## APPENDIX B

### Schedule of Modifications to the Site Allocations DPD

# Map 1: Highgate Bowl Site Allocation & Open Space

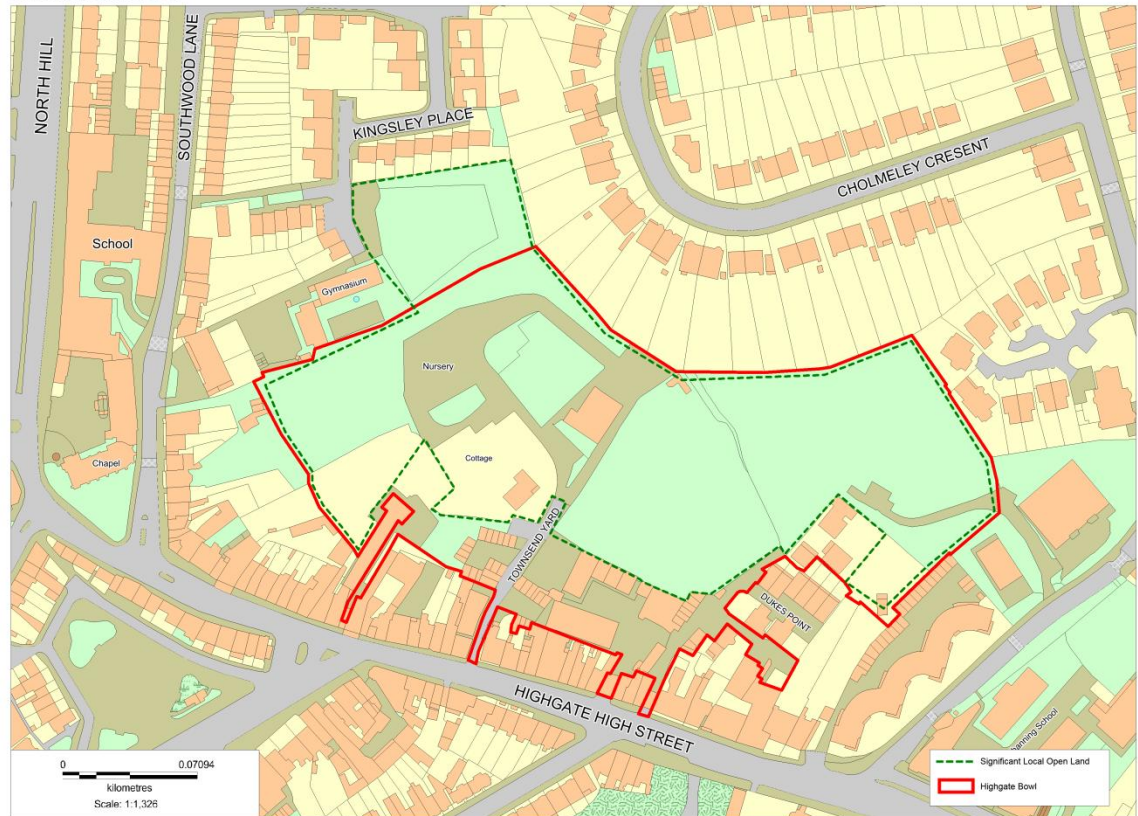
SAMM80	SA 42	<i>Amend the site allocations map for Site Allocation SA42: Highgate Bowl to show the potential open space boundary within the site as set out in the Preferred Option consultation document.</i>
SAMM81	SA42	<i>Amend the third 'Site Requirement' as follows:</i>  <a href="#">Limited and sensitive development within the Yards offers the opportunity to secure the area identified by and lying within the green line on the site allocation and Policies Map as designated open space Highgate Bowl itself will be redefined as Significant Local Open Land.</a>
SAMM82	SA42	<i>Amend the fifth 'Site Requirement' as follows:</i>  <a href="#">Enhanced Public</a> access to the Bowl will be <a href="#">required supported</a> through the <a href="#">arch of Duke's Head Yard, and through Townsend Yards</a> .
SAMM83	SA42	<i>Amend the sixth 'Site Requirement' to read:</i>  Public routes through the various land parcels that make up the 8Bowl could be introduced to unify the open space, <a href="#">subject to the operational requirements of existing landowners and/or occupiers</a> .

<b>Modifications to the Policies Map</b>	
MapMod1	Add Highgate Bowl Open Space to SA42, and Policies Map (set out below)
MapMod2	Amend SA41 as set out below
MapMod3	Amend SA31, SA33, SA 34, TH11, and TH13 to be only Local Employment Area: Regeneration Area, from dual designation as Local Employment Area: Regeneration Area and Locally Significant Industrial Site.
MapMod4	Amend Cranford Way, White Hart Lane, Queen Street, Willoughby Lane, Roseberry Works/Lindens and the residual DEA16 (apart from SA33 & SA34) to be only Locally Significant Industrial Site, from Locally Significant Industrial Site and Local Employment Area: Employment Land.
MapMod5	Amend South Tottenham from part dual designated Locally Significant Industrial Site/ Local Employment Area: Employment Land, to Locally Significant Employment Site only. TH11, 12 & 13 to be Local Employment area: Regeneration Area only as per existing/amendment MapMod3)
